**ALLENDALE CHARTER TOWNSHIP
PLANNING COMMISSION MEETING**

To: Allendale Charter Township Planning Commission
From: Gregory L. Ransford, MPA 
Date: October 12, 2021
Re: 6138 LMD Planned Unit Development – Final Plan

RE: 6138 Lake Michigan Drive. Review comment responses from letter dated 8.25.2021

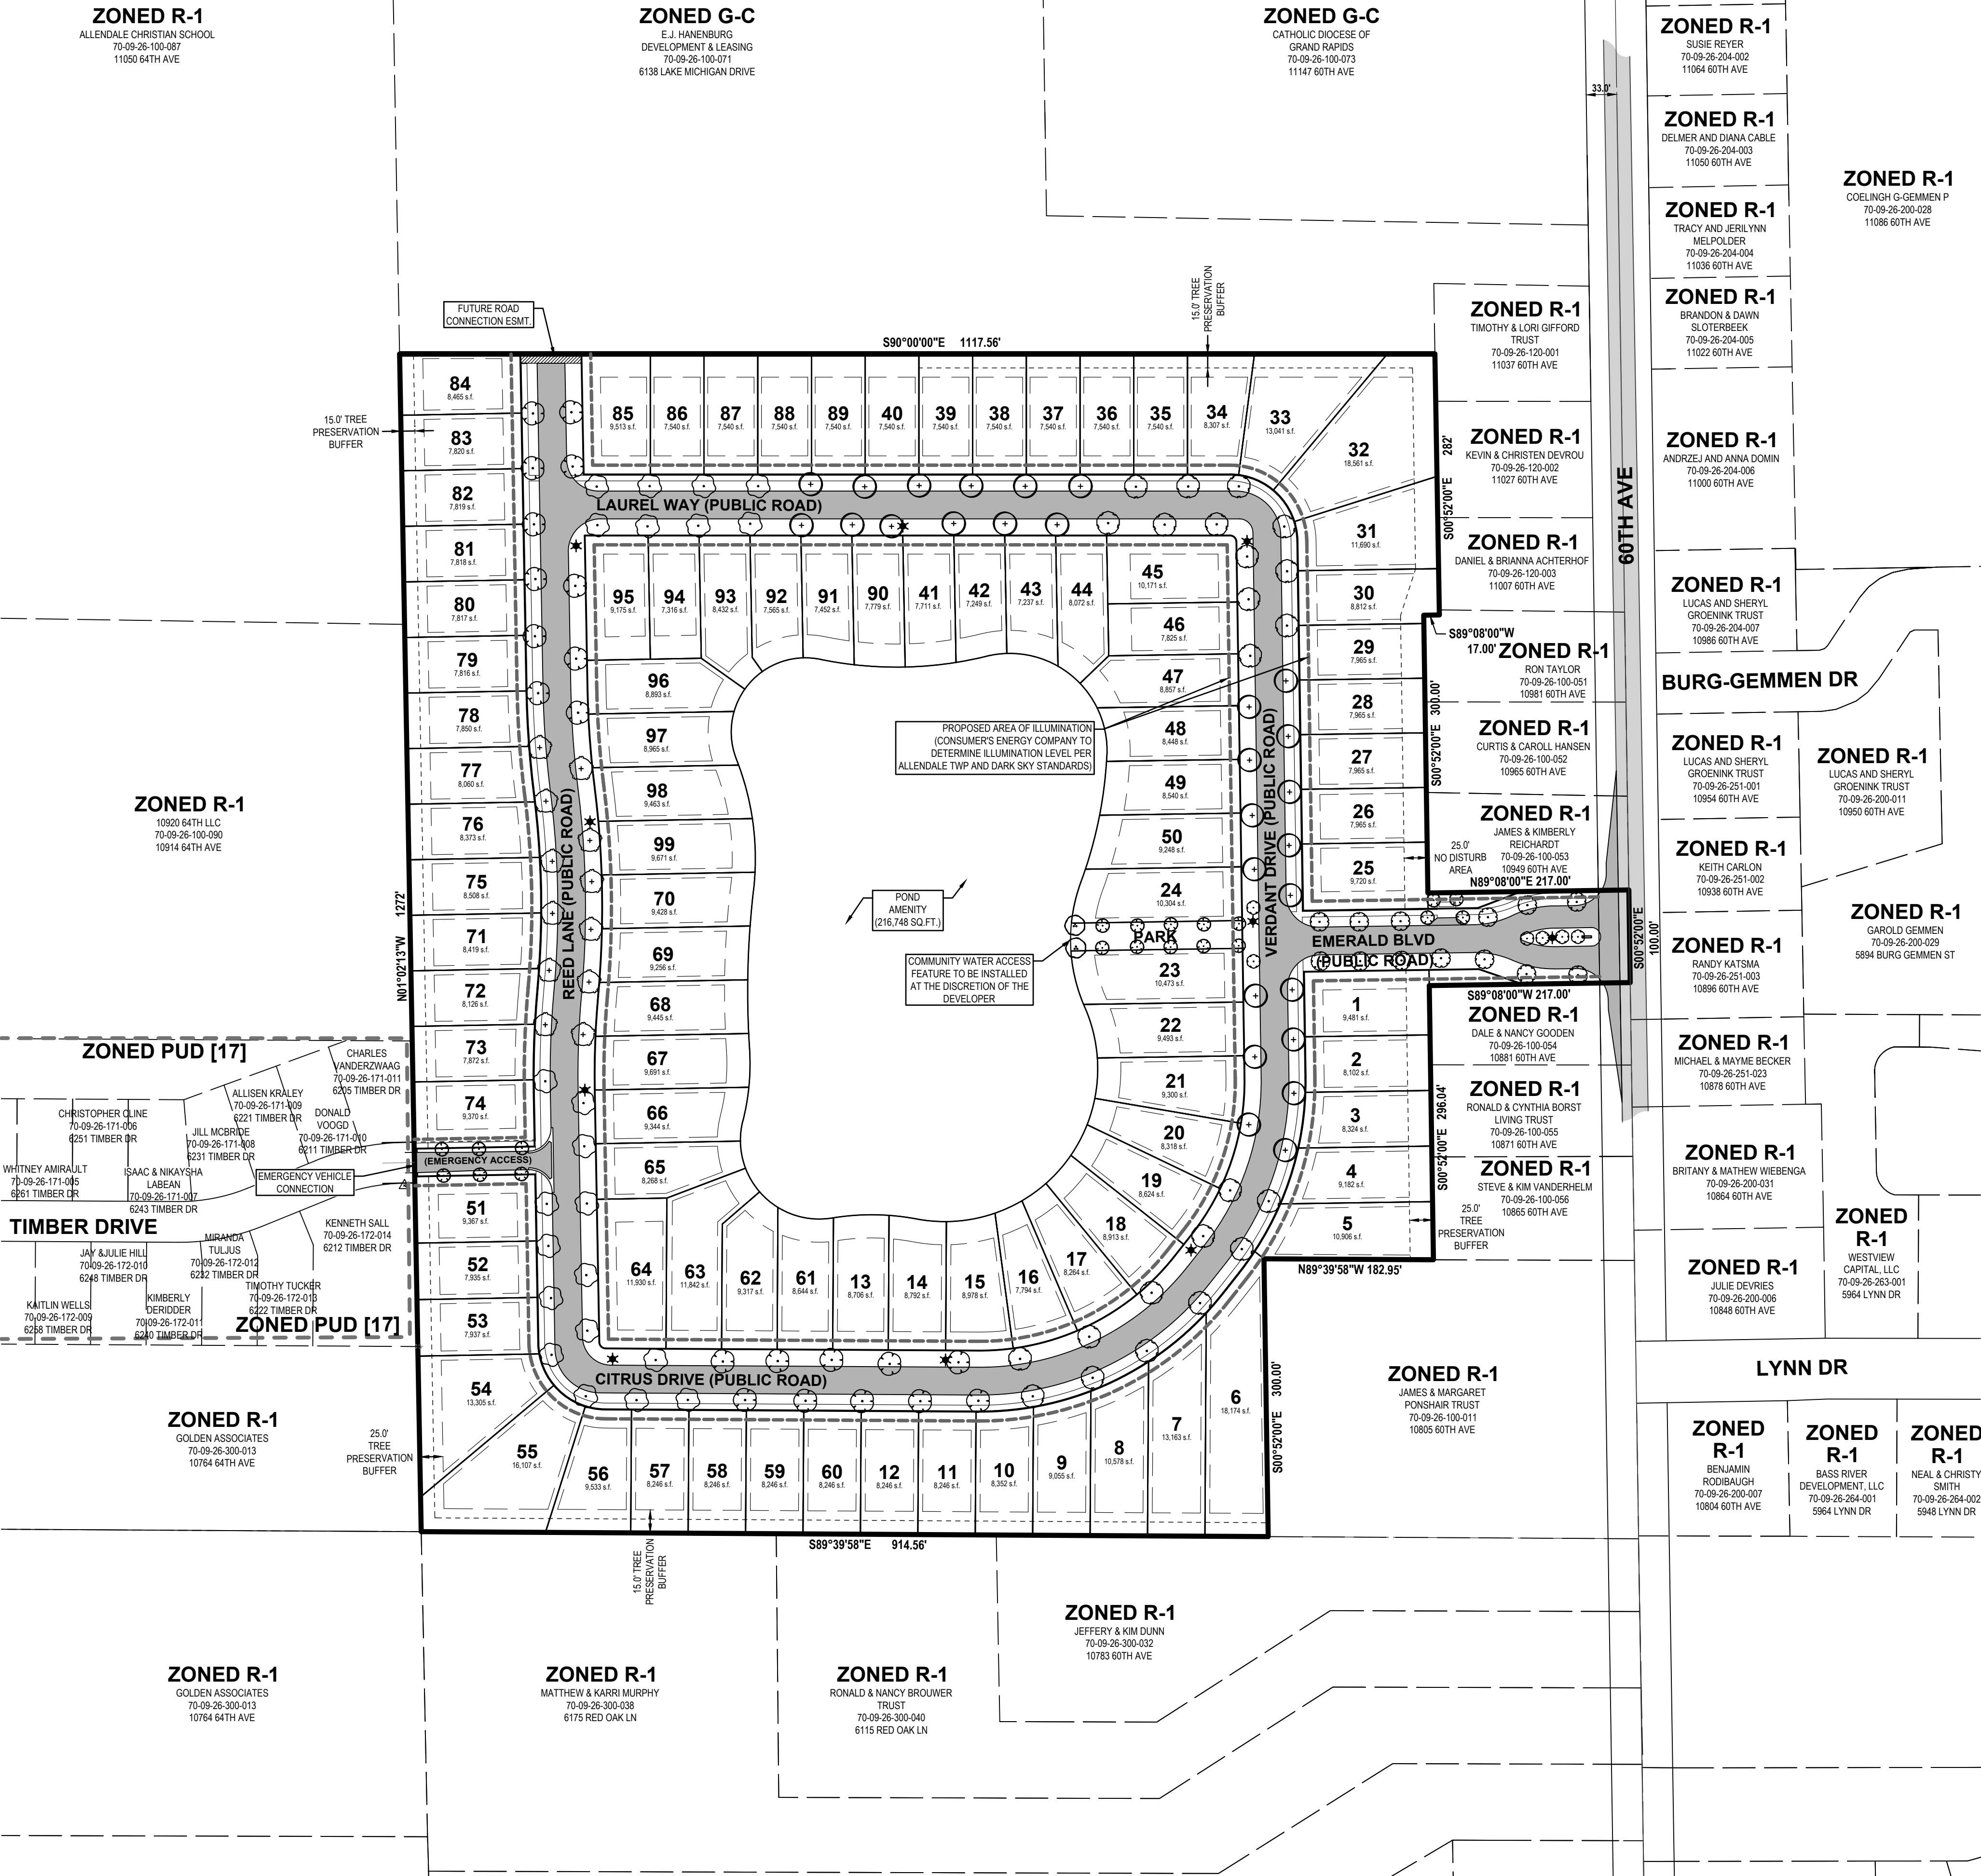
As you are aware, concerns were expressed by the public regarding street lighting and its effects on adjacent property. In response, the applicant provided a “proposed areas of illumination” plan note within Sheet L-200, which points to the dashed lines adjacent to the right-of-way. The note further indicates that the illumination levels will be determined by Consumer’s Energy. Unless the process through Consumer’s Energy has changed, we understand that several light fixtures are available to choose from, such as the fixture identified on the same plan sheet, which should have available illumination data. We contemplate whether light fixtures would provide illumination in such a parallel manner to the road. Moreover, it appears that some of the identified illumination areas are on sides of the street where light fixtures are not present.
